NORTH RIM

MASTER DEVELOPMENT PLAN (MDP)

Re: North Rim **MDP # 051-06**

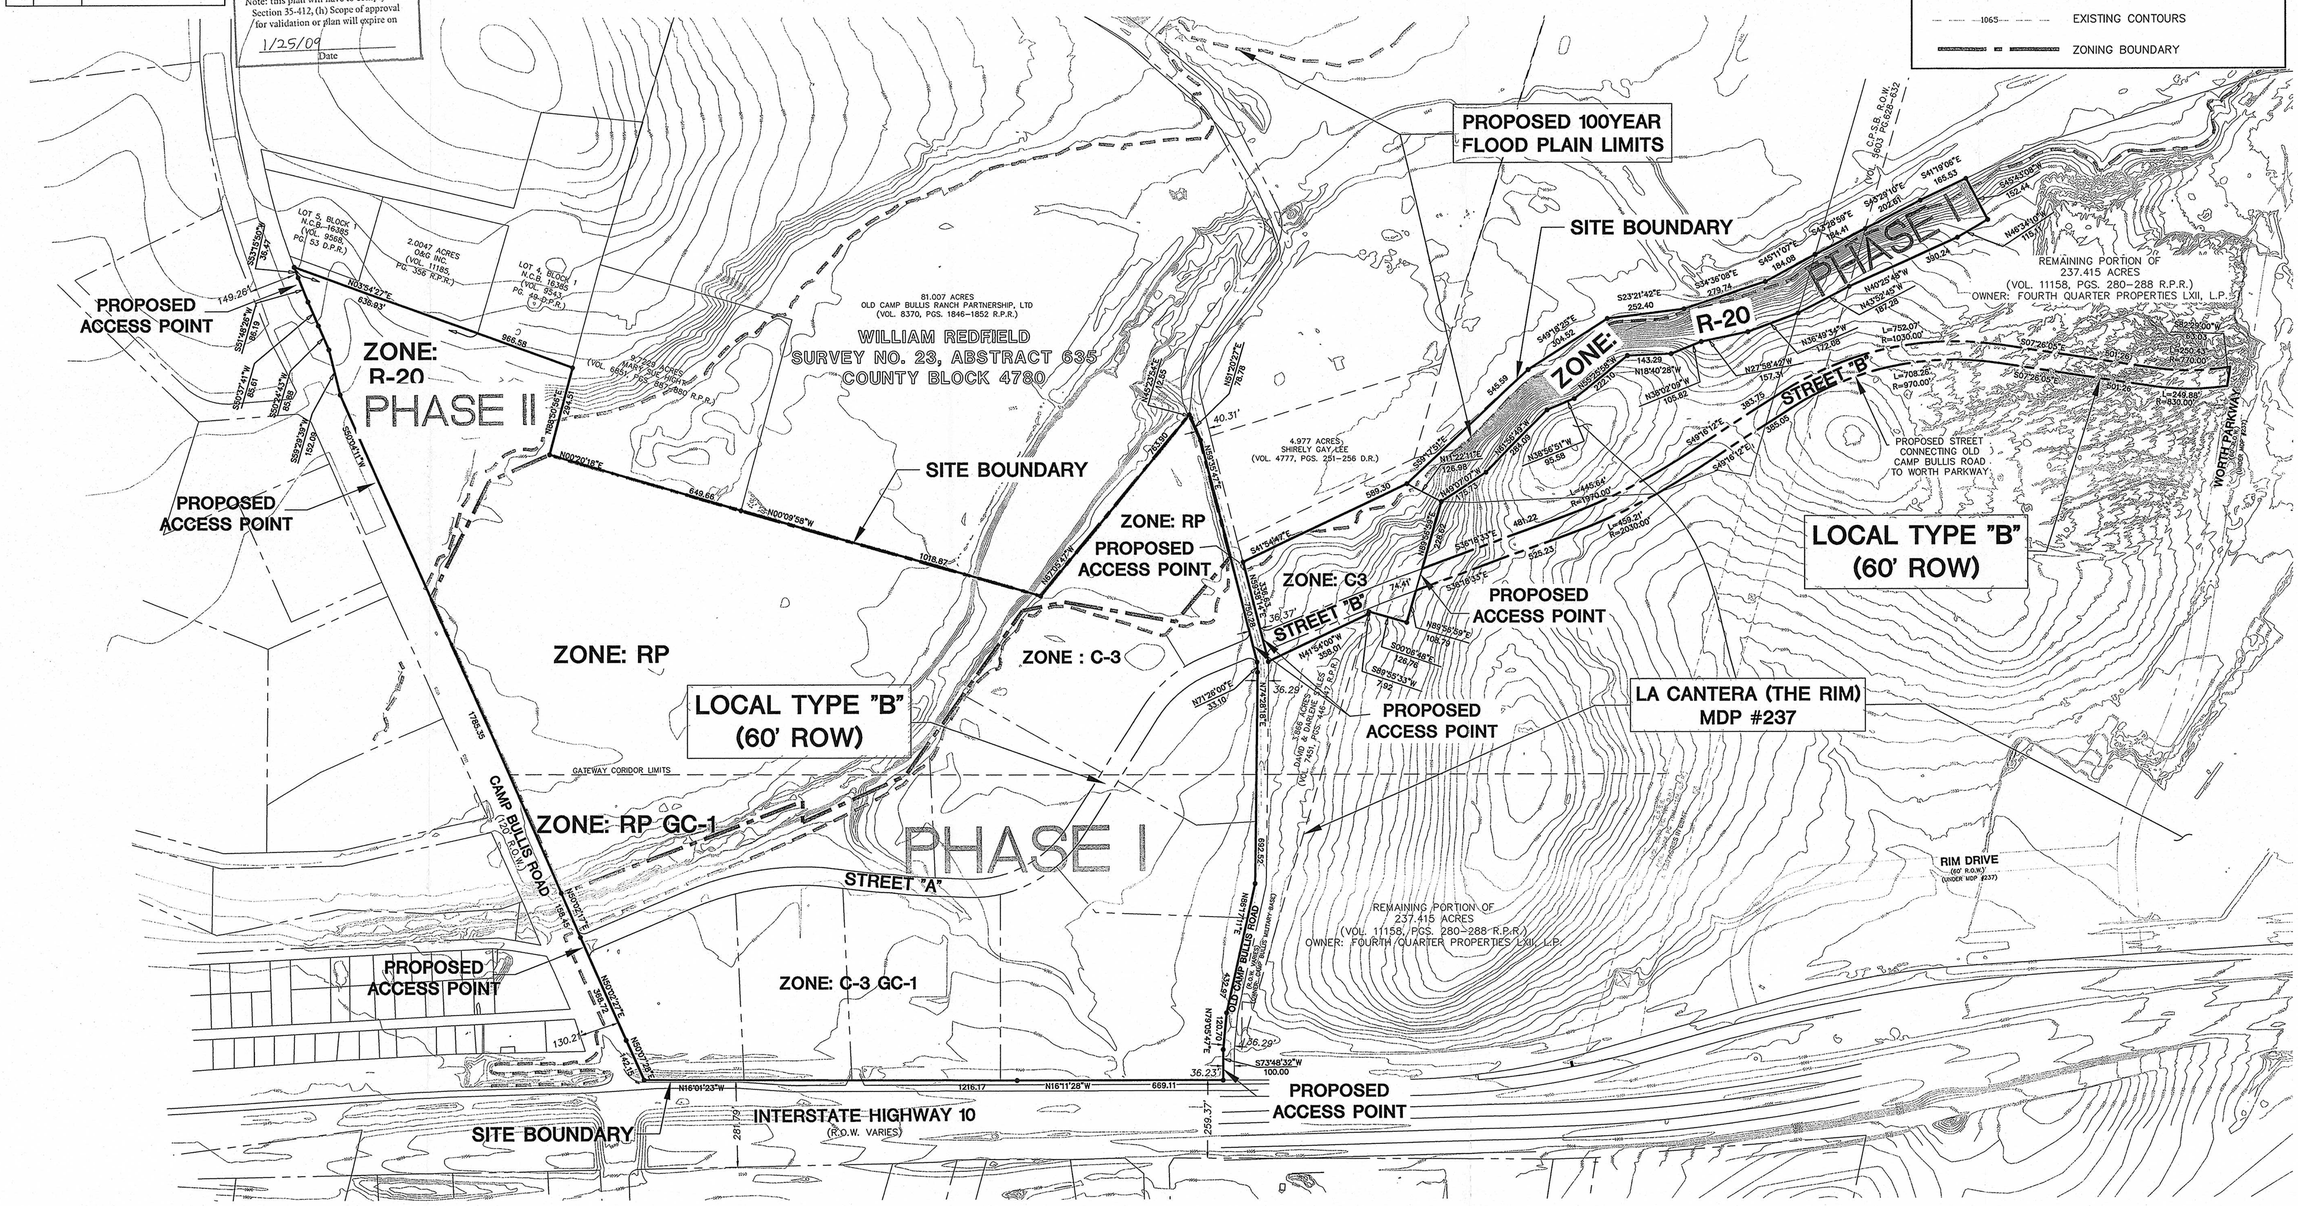
- Driveway throat lengths shall comply with UDC 35-506, Table 506-7 requirements.
- All commercial driveways for this project shall comply with UDC 35-506, (r) Access and Driveways.

- All access driveways shall provide clear sight distance along IH 10 Frontage Road to provide adequate obstruction free viewing distances for approaching traffic. All signage, landscaping, and improvements shall be selected and located so as to not block these clear sight distances areas.

- All access roadways shall provide clear sight distance on all existing and proposed roadways in order to provide adequate obstruction free viewing distances for approaching traffic. All signage, landscaping, and improvements shall be selected and located so as to not block these clear sight distances areas.

- The developer shall be responsible for providing right-turn deceleration lanes with storage lengths and bay taper in all the driveway access point approved by TXDOT as it relates to the submitted TIA traffic counts, Unified Development Code (UDC) – 35-502 (a)(7), subsection C. Including the following driveways:

1. IH 10 WBSR at Driveway A
2. Camp Bullis Road at Driveway B
3. Camp Bullis Road at Driveway C

Note: Texas Department of Transportation (TXDOT) will determine access point along frontage road.

- Any improvements along Old Camp Bullis will be determined at time of Platting / Permitting.
